North American Tungsten Corporation Limited

RESPONSE TO YESAB'S ADEQUACY REVIEW REPORT
OF SUPPLEMENTARY INFORMATION RESPONSE
FOR THE PROPOSED MACTUNG MINE, MACMILLAN PASS, YUKON
(YESAB PROJECT NUMBER: 2008-0304)

ADDENDUM 2 OF THE MACTUNG PROJECT PROPOSAL

EBA FILE: W23101211.002

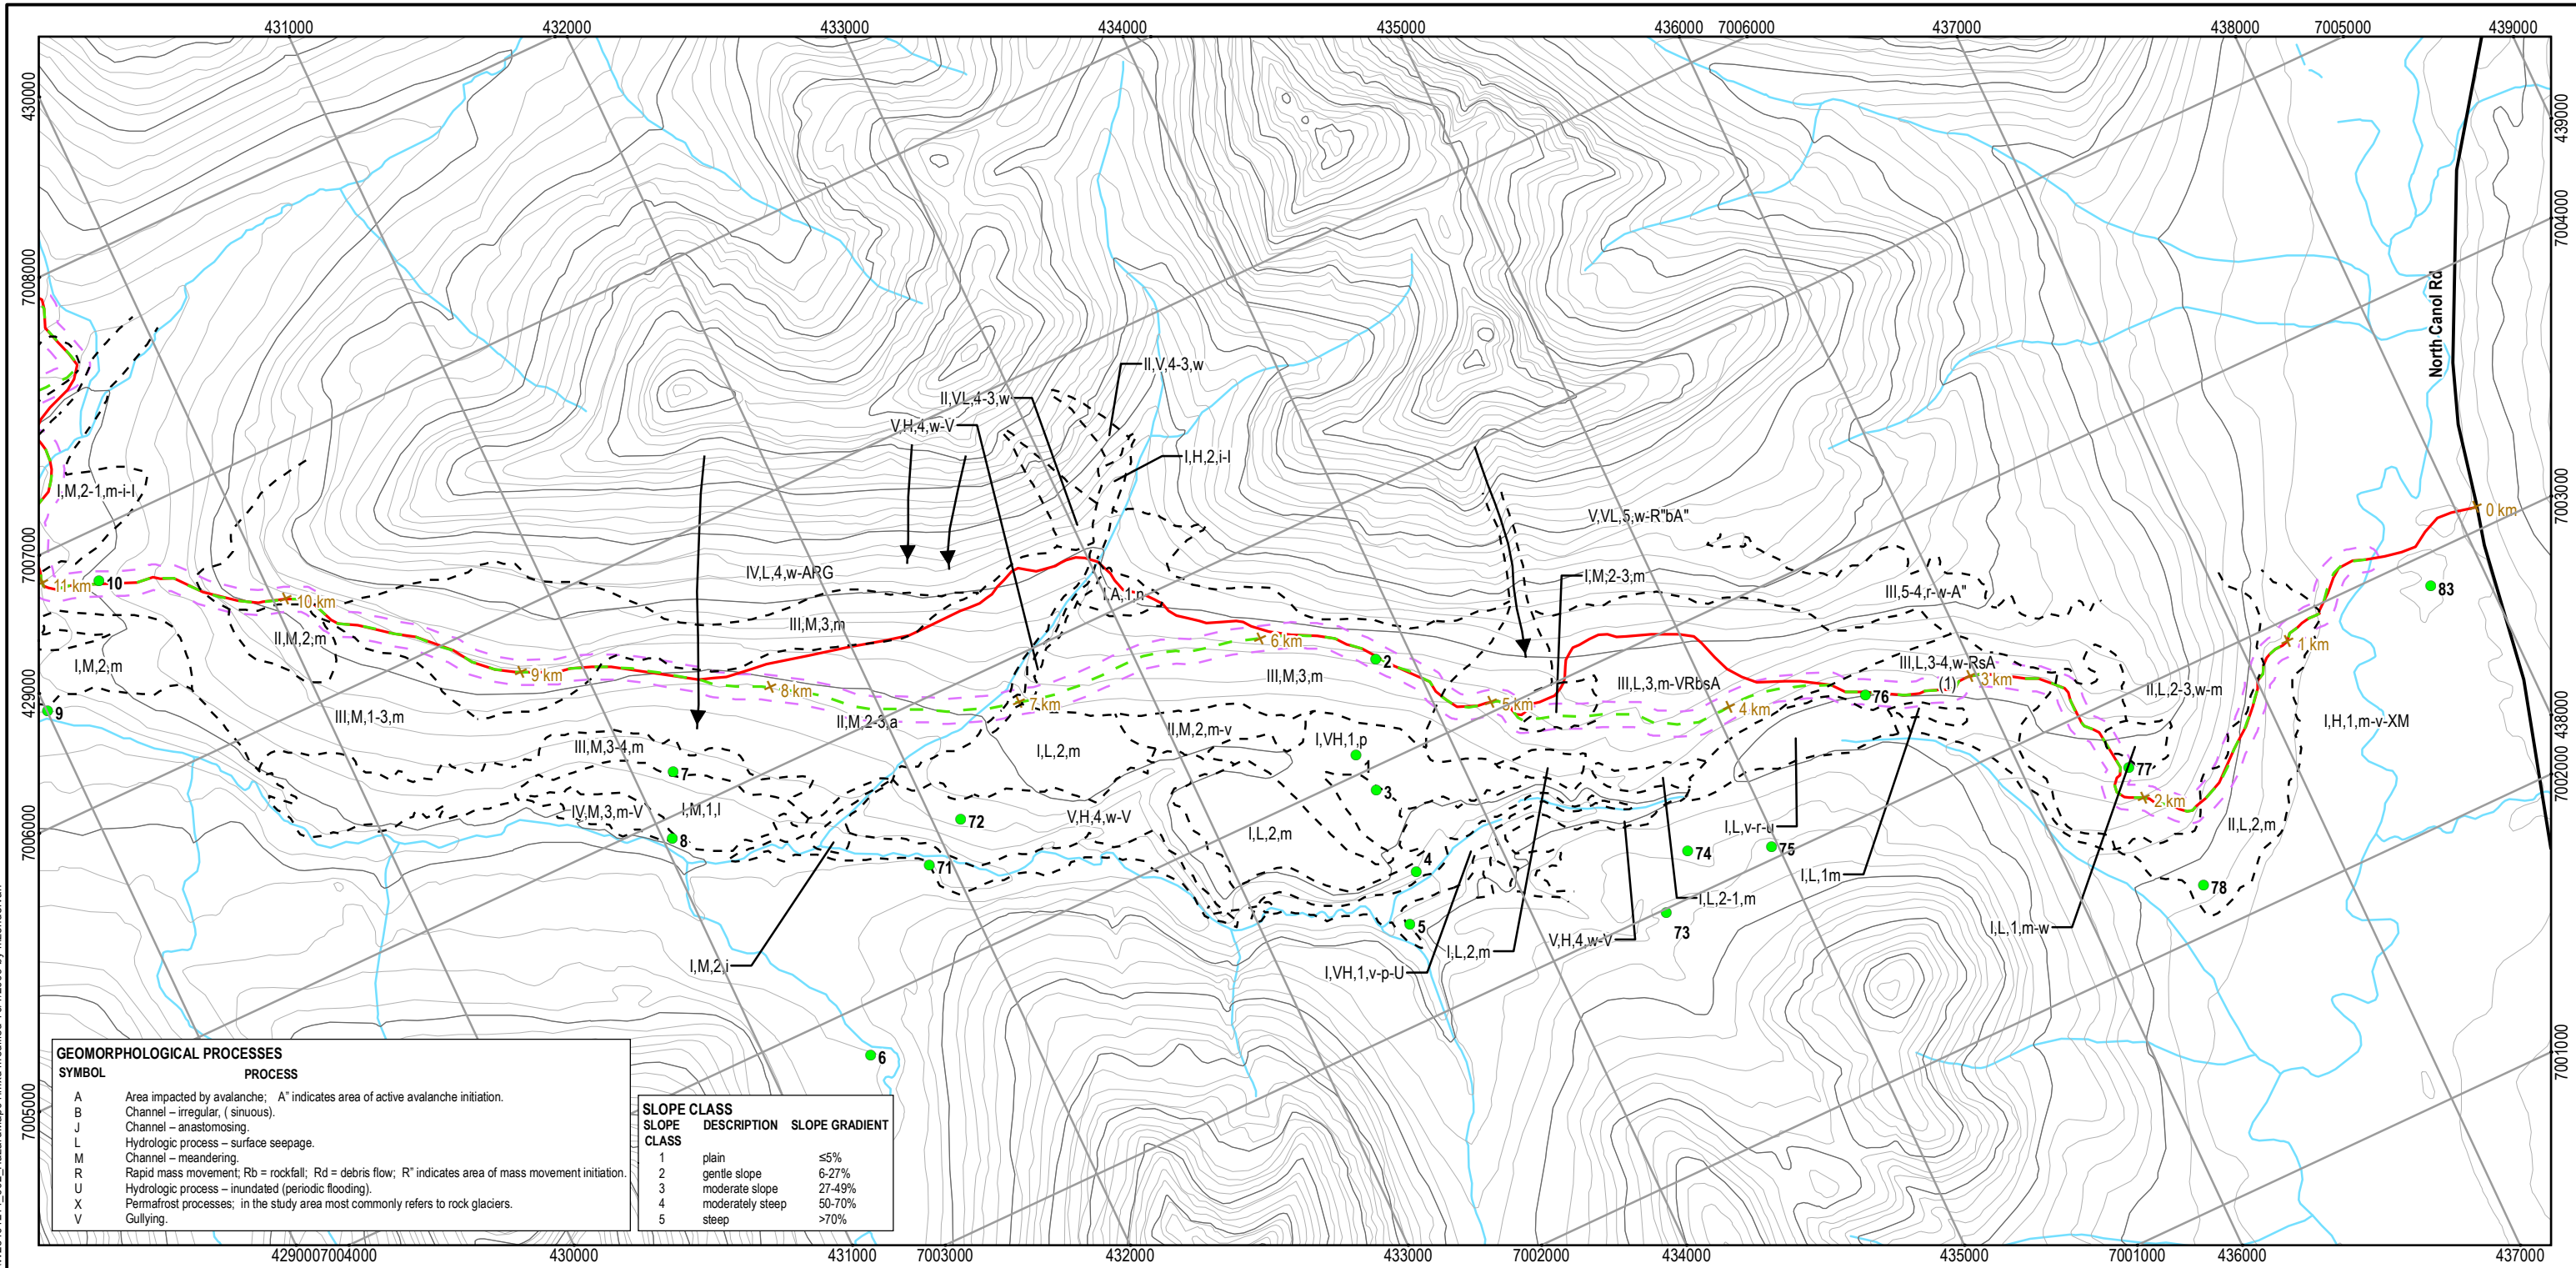
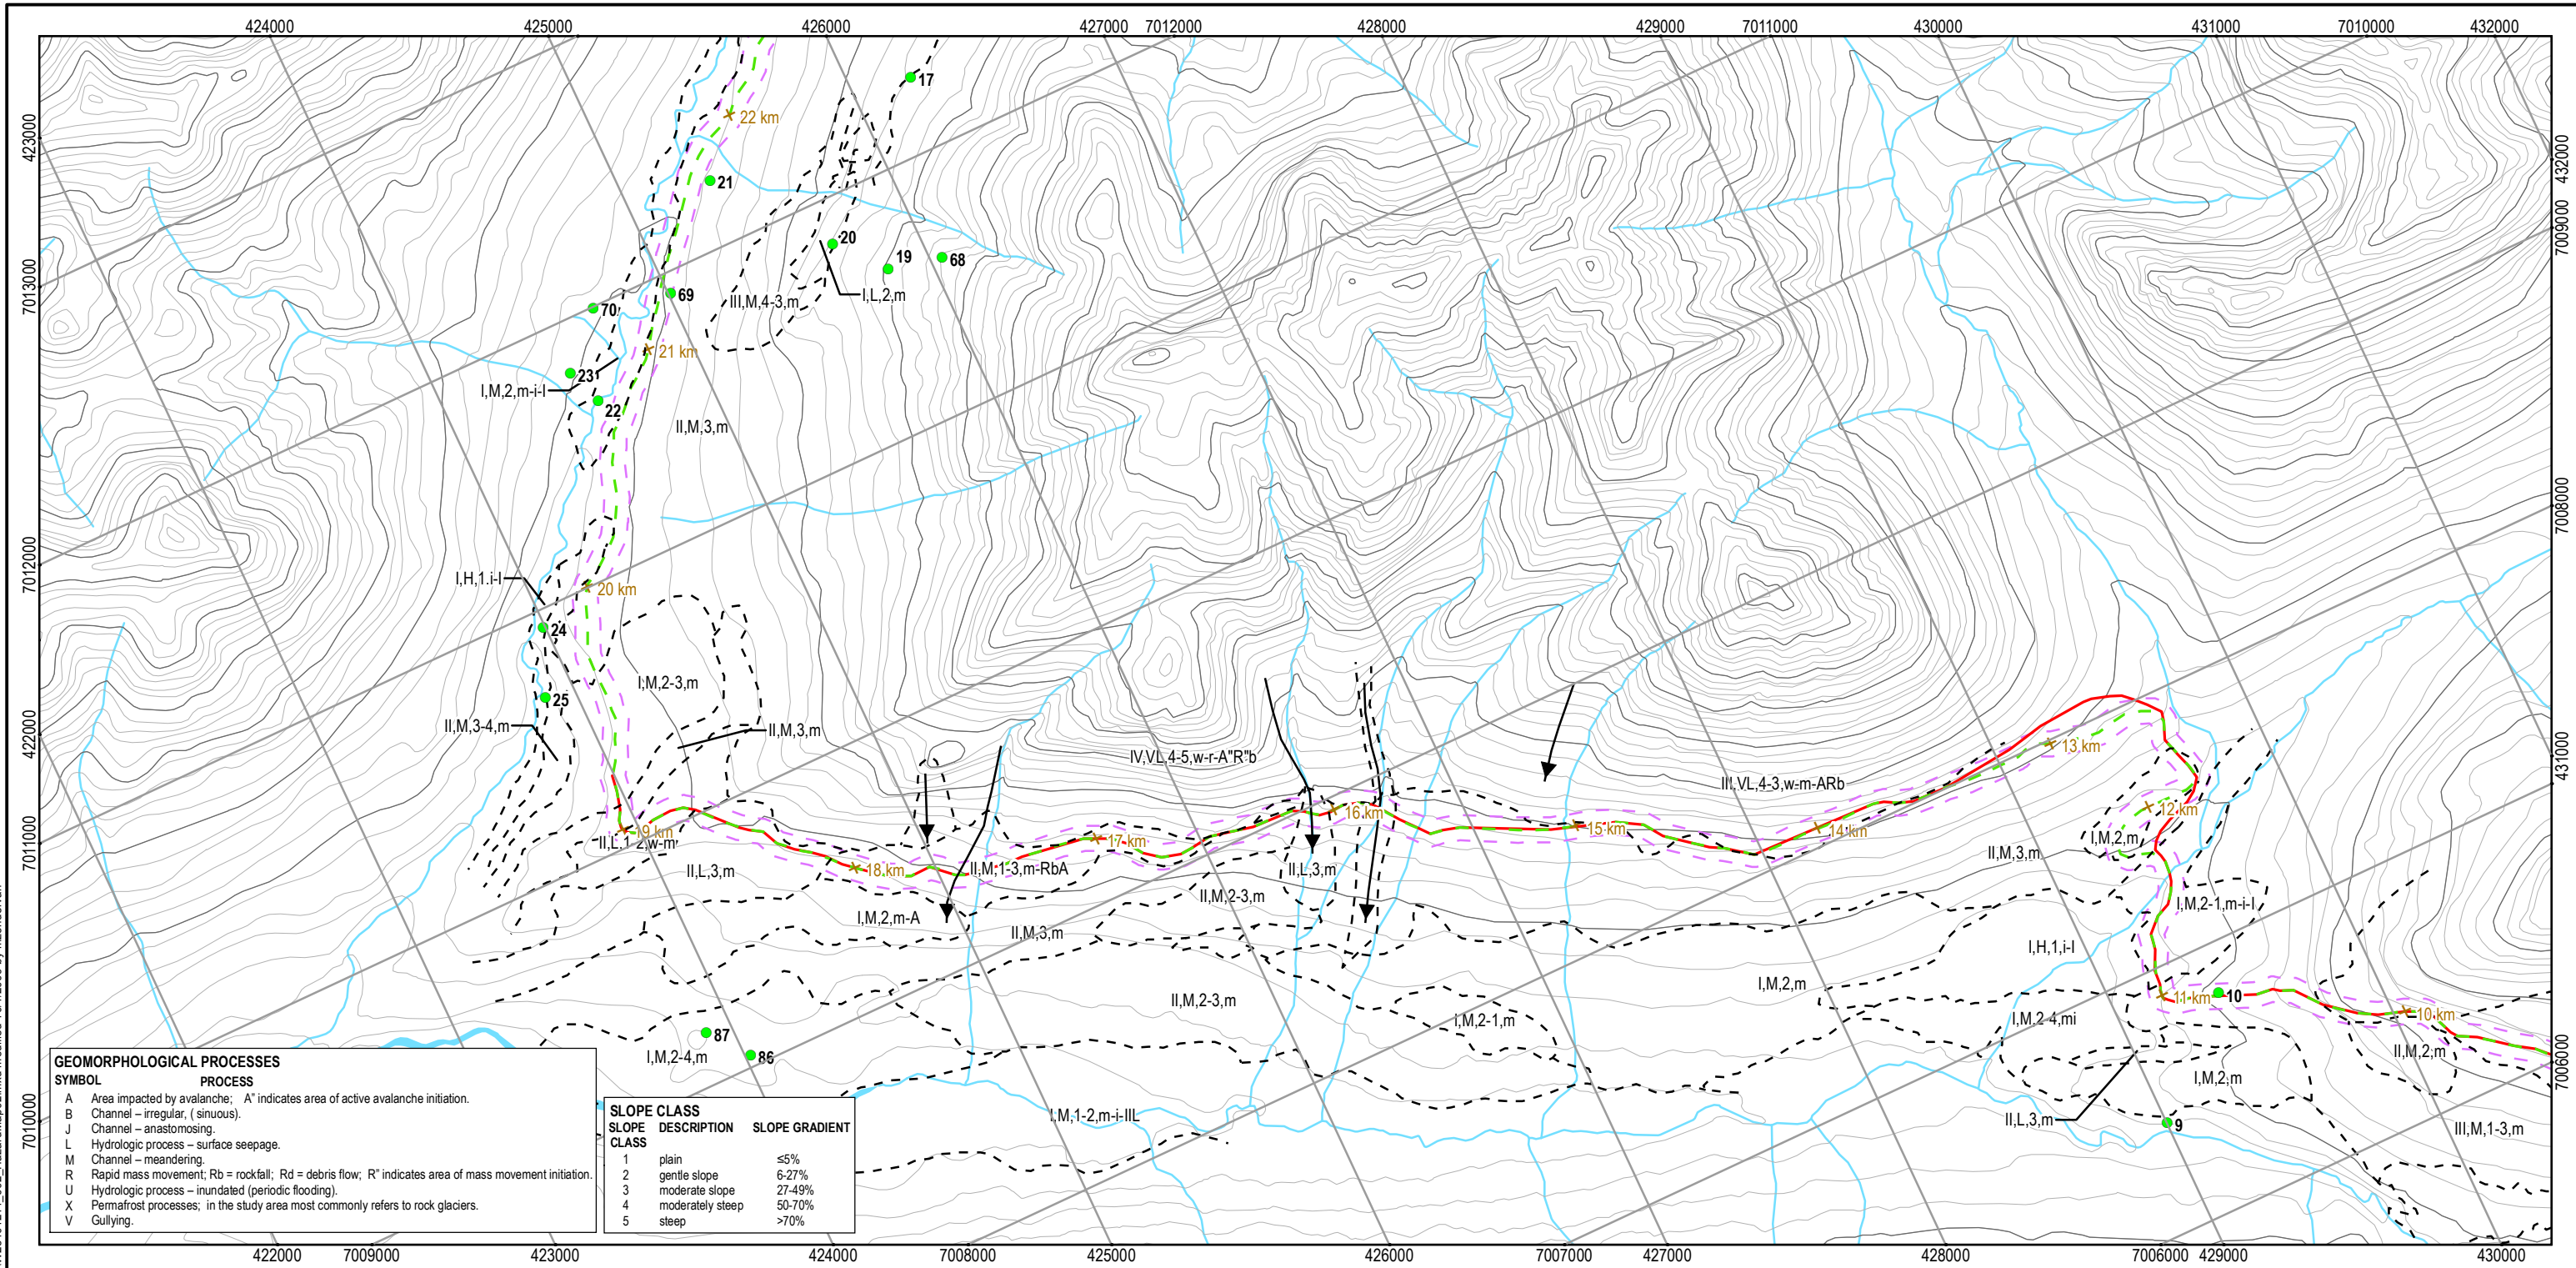
- a) A route map at an appropriate scale to show the location of the proposed access road relative to surrounding terrain features and topography, particularly those terrain units that could constrain routing (geo-hazards). An example of appropriate terrain mapping for linear developments can be found in the proposal for project #2006-0286 (Yukon Energy Corporation Carmacks-Stewart/Minto Spur Transmission Project).

Please refer to Figures 1.1-1.5 contained within Appendix B for mapping of the proposed mine road and associated terrain features. The Figures have been identified as "Preliminary" as they have been developed for assessment purposes only and are not suitable for site construction.

It should be noted that Figures 1.1-1.4 displays terrain hazard mapping based on an analysis of the area along the road route from the North Canol Road to approximately ten kilometres from the mine. Figure 1.5 presents the terrain mapping for the remaining ten kilometres in the immediate mine area with more detail, as a result of the extensive ground work conducted by NATC in the mine site area on the companies mining claims.
